Request for Advice – Exhibition of [Hudson Vine Mixed Use Redevelopment](#)

Thank you for your correspondence dated 2 April 2025 inviting the City of Sydney (the City) to comment on the exhibition of the Hudson Vine Mixed Use Redevelopment at 2-14 Vine Street, 16-30 Vine Street and 32-34 Eveleigh Street.

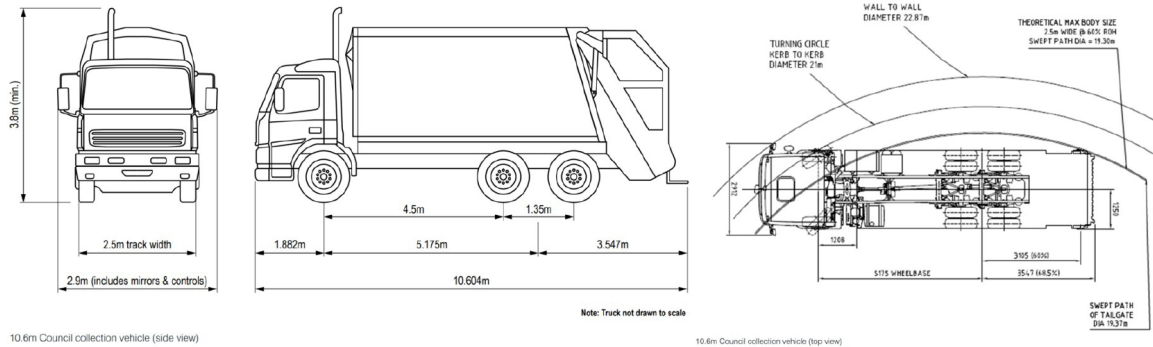
- a) Driveway crossover width is not documented. Sydney Streets Technical Specifications – Standard Drawings (2.2.10) require a maximum width of 5.4m for a dual lane crossover.

The architectural plans show the driveway to Hudson Street labelled 'NEW DRIVEWAY CROSSOVER'. If this is a new crossover, drawings must document full dimensions of the proposed new driveway. If this design plans to reuse the existing crossover, it should be identified as being drawn from surveyed data and not be labelled as 'NEW'.
